Addendum No. 03

Clovis East Soccer Complex

PBK PROJECT NO.: S2103100AR
DSA FILE NO.: -
DSA APPLICATION NO.: 02-120099, 02-120158, 02-120503

BLEACHERS/ STADIUM LIGHTING/ SCOREBORAD DRAWINGS:

1 ELECTRICAL SINGLE LINE DIAGRAM SCALE: NTS

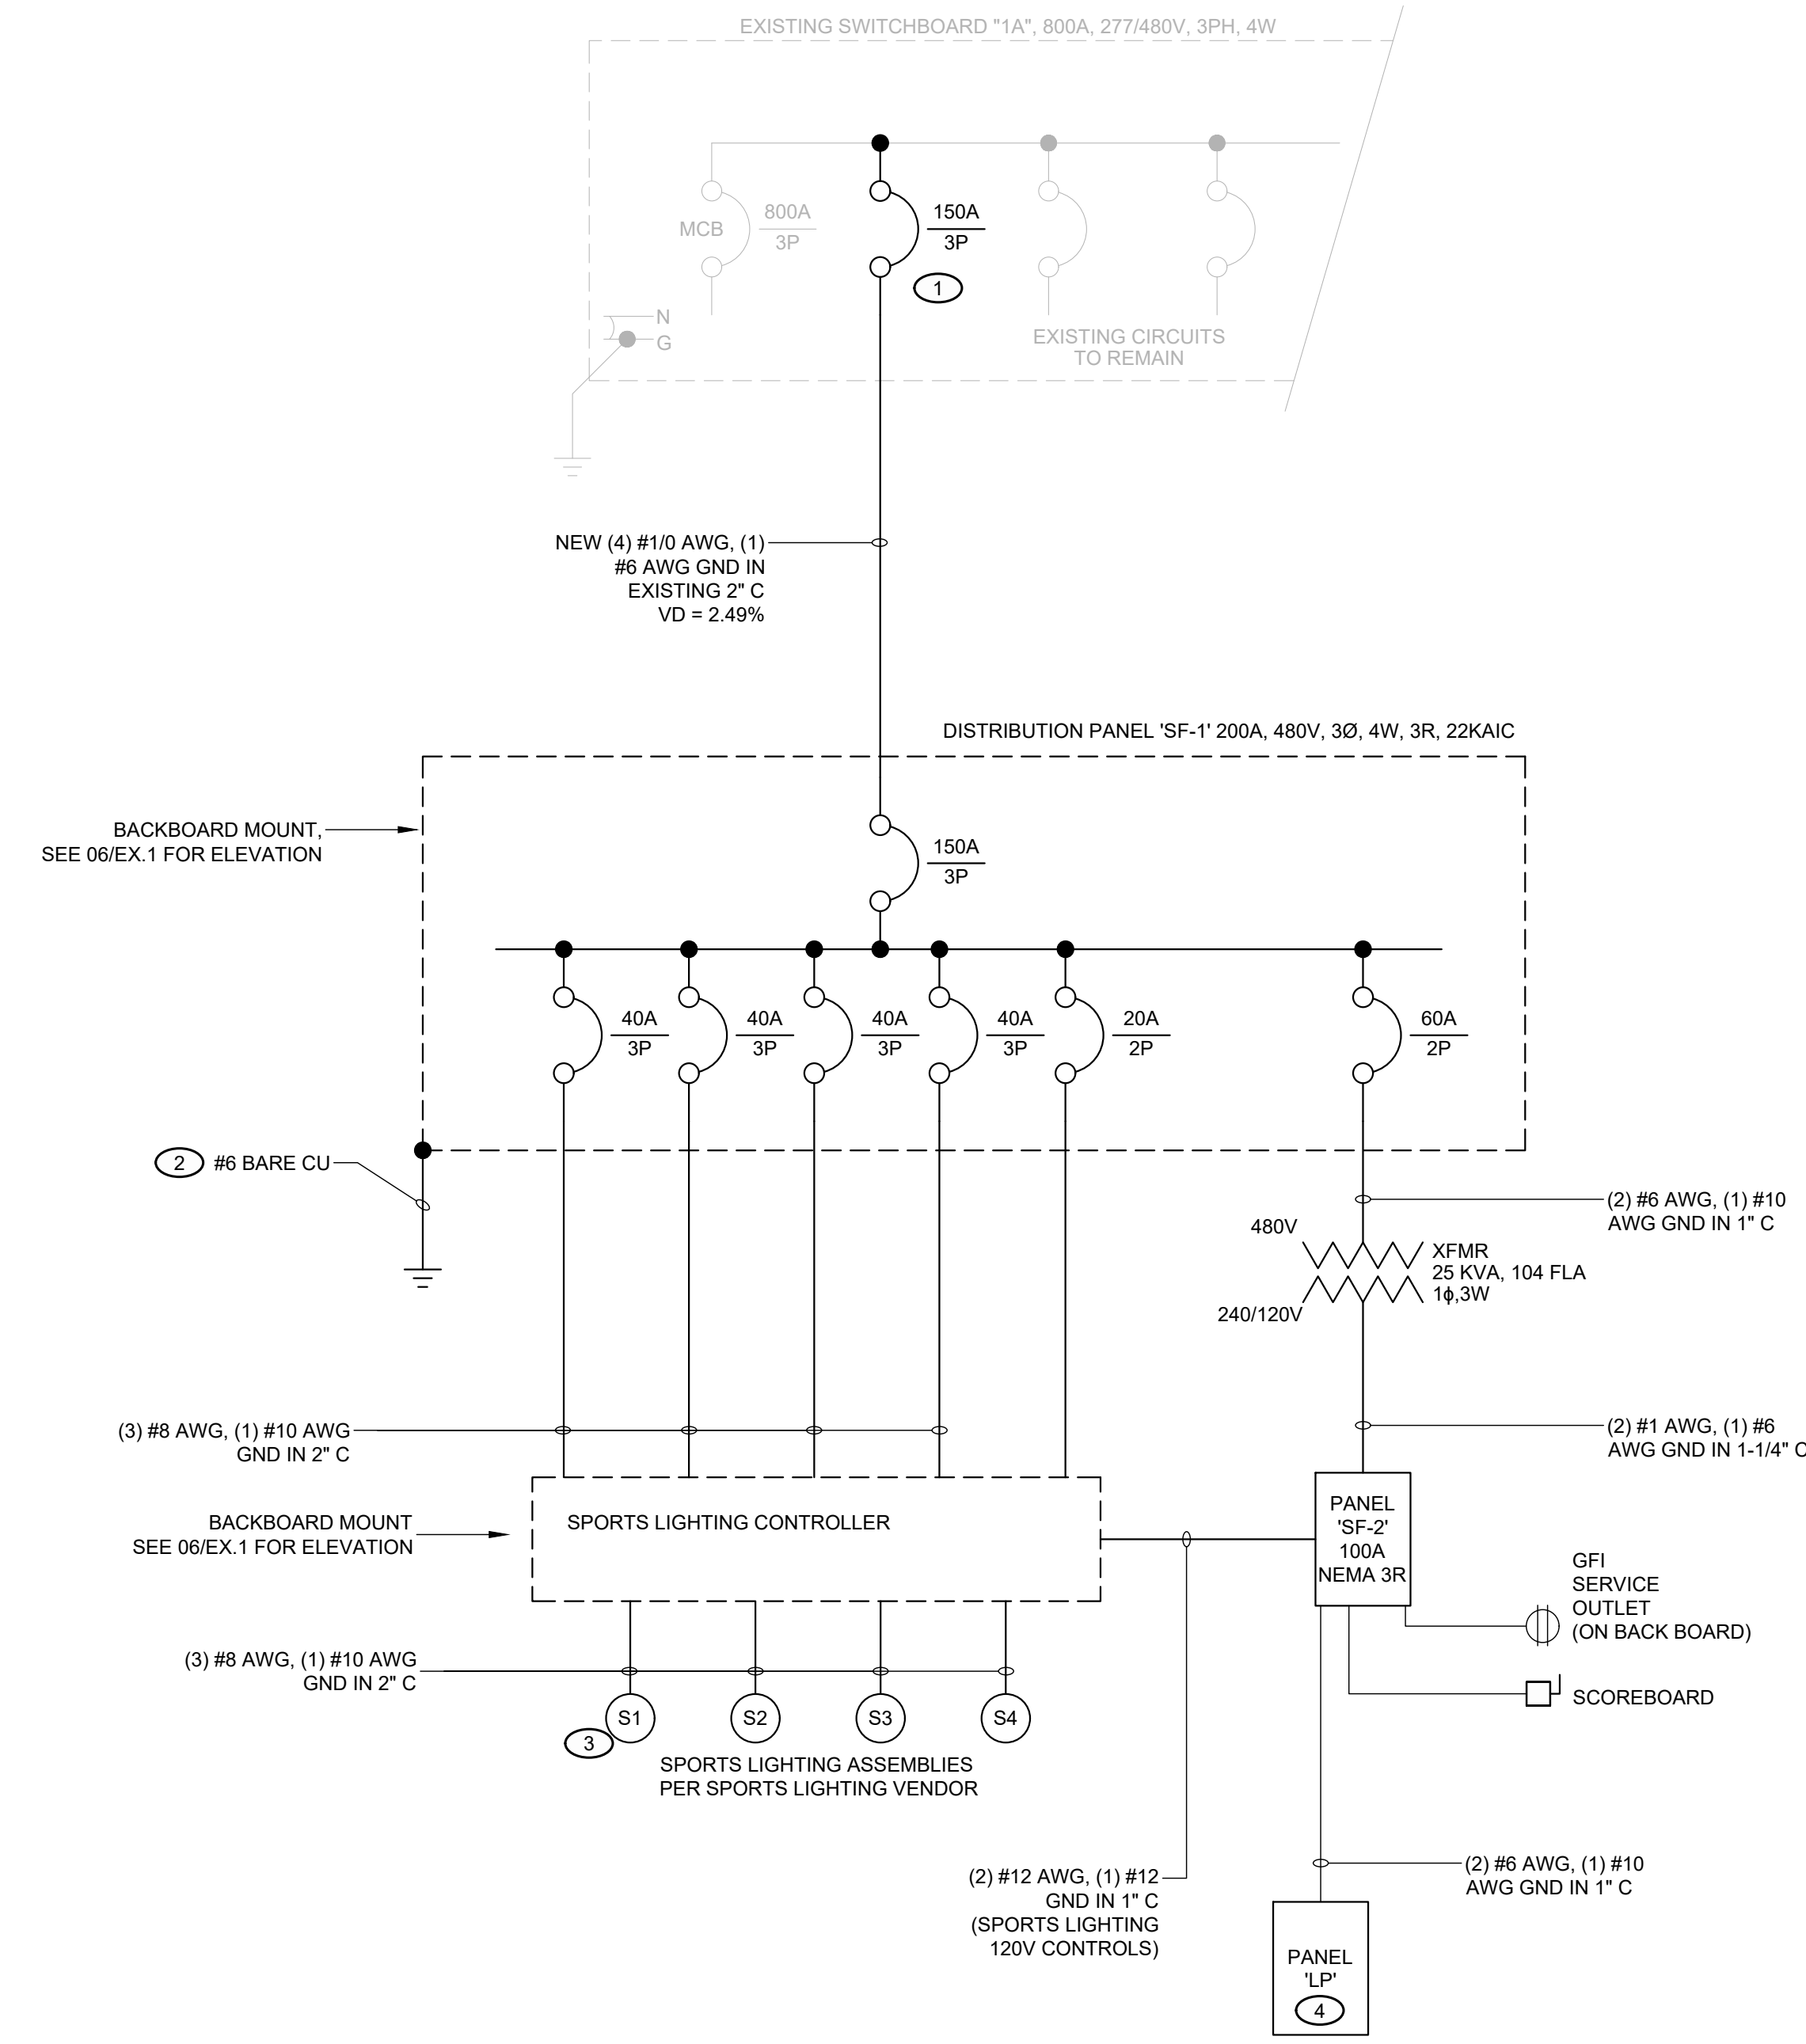
- 3-01 Sheet E0.1 – ELECTRICAL SHEET INDEX, LEGEND & NOTES**, revise as follows:
Add Sheet. See attached
- 3-02 Sheet E1.0 – ELECTRICAL SITE PLAN & PRESS BOX PLAN**, revise as follows:
Revised plans. See attached.
- 3-03 Sheet E6.1 – ELECTRICAL SINGLE LINE DIAGRAM**, revise as follows:
Revised diagram. See attached.
- 3-04 Sheet EX1 – ELECTRICAL DETAILS**, revise as follows:
Adde sheet. See attached.

1. PROVIDE NEW CIRCUIT BREAKER IN (E) MAIN SWITCHBOARD AVAILABLE SPACE.
2. PROVIDE A GROUNDING ELECTRODE SYSTEM IN ACCORDANCE WITH CEC 250.30. AT THE NEW BACKBOARD PROVIDE (2) 5/8"X8' GROUND ROD, SEPARATED BY 6' (MIN). SEE DETAIL 02/EX.1 FOR GROUND ROD DETAIL.
3. PROVIDE GROUNDING ELECTRODE AT EACH SPORTS LIGHTING POLE BASE PER THE SPORTS LIGHTING VENDOR DESIGN DOCUMENTS.
4. PANEL LP IS INTEGRAL TO THE PREFABRICATED PRESS BOX AND PROVIDED BY THE PRESS BOX SUPPLIER. SEE SHEET B13 FOR THE PANEL SCHEDULE.

ELECTRICAL EQUIPMENT ELEVATION N.T.S 06

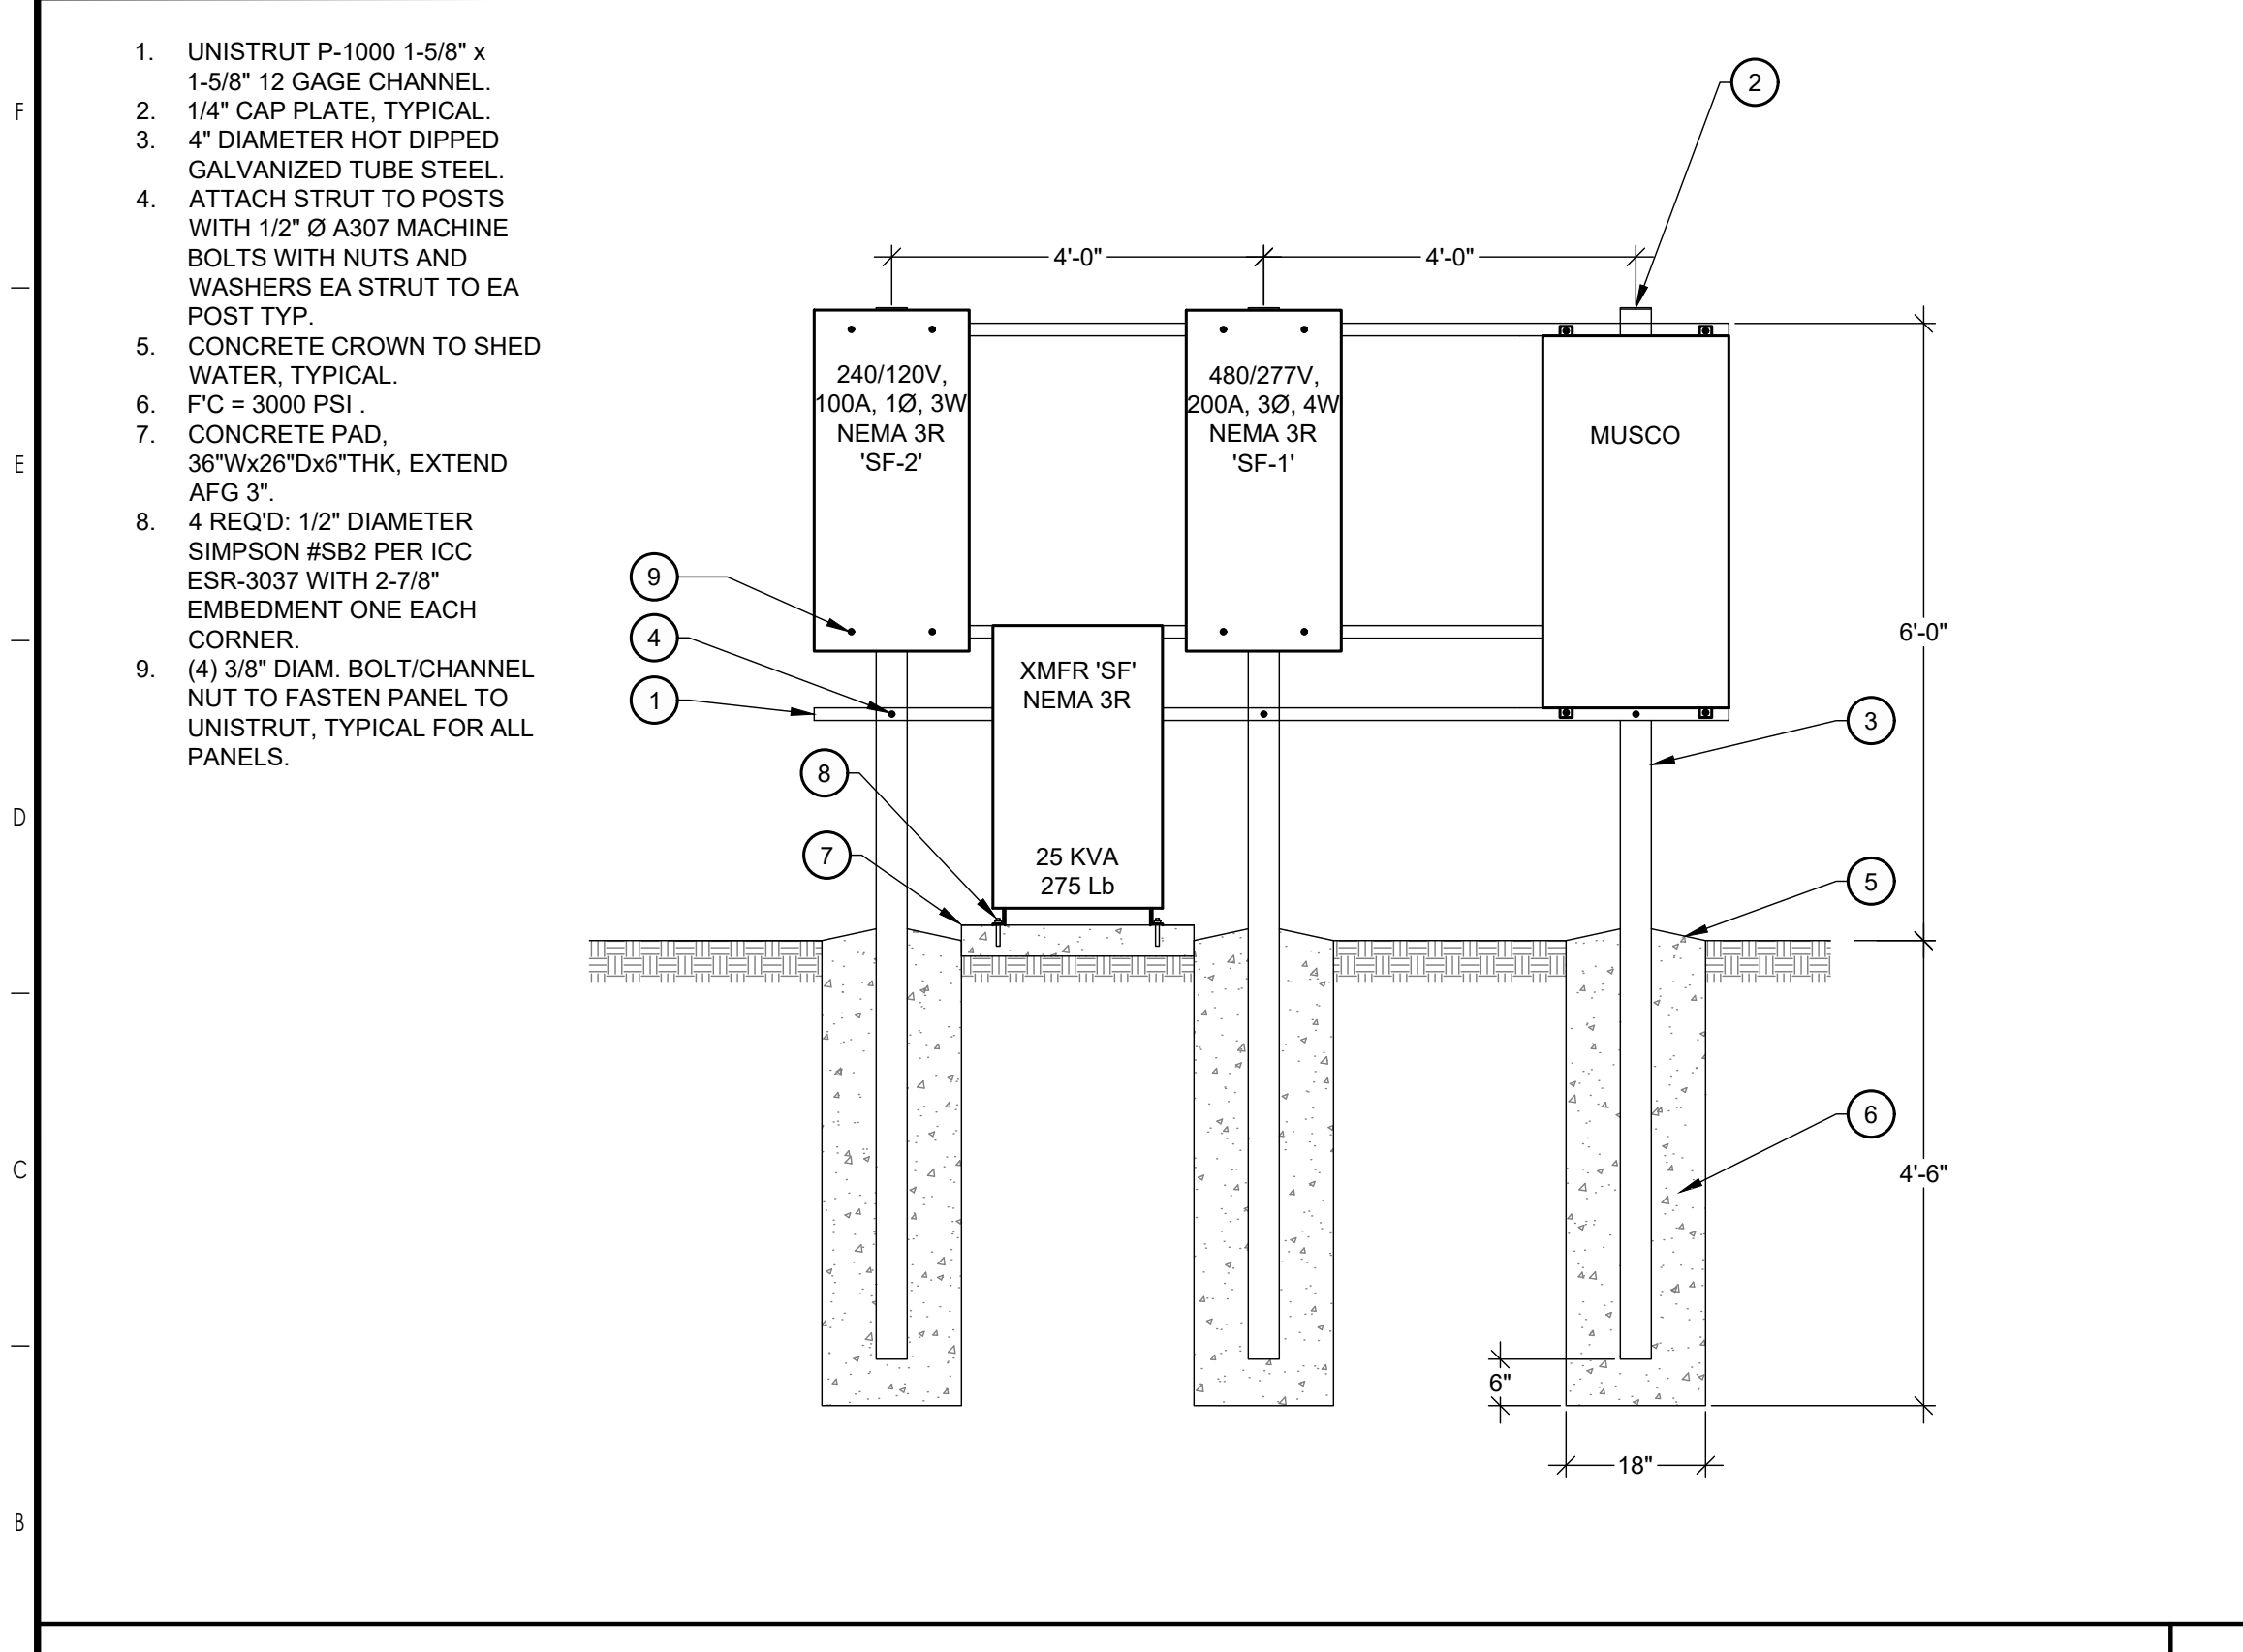
6	11/3/22	Is there a detail for the panel backboard that is mentioned on keynote 3 on sheet C_1.0 in the bleacher drawings?	Durham Construction	To be addressed in Addendum 3	LEAF 11/4/22				
7	11/3/22	At the pre-bid we walked the site looking for the existing panels that are noted in the concession stand plans on sheet E_1.1. The location that is shown is not where the panels are located. The location of the panels is also shown on the bleacher drawings on sheet E_1.0, but these are different panels that what is noted on the concession drawings. Can I please get clarification on where the existing panels are located?	Durham Construction	To be addressed in Addendum 3	LEAF 11/4/22				
8	11/3/22	Is there a General Conditions section? Specifically 00700?	New England Sheet Metal	See attached spec section 00700. SM - PBK 11/4/22					11/4/22

- 3 PROVIDE NEW EQUIPMENT BACKBOARD WITH PANELS 'SF-1' AND 'SF-2' AND 25 KVA TRANSFORMER 'SF' PER THE SINGLE LINE DIAGRAM. INSTALL THE SPORTS LIGHTING CONTROL PANEL PER THE SPORTS LIGHTING VENDOR PLANS. SEE DETAIL 06/EX.1 FOR MORE INFORMATION.
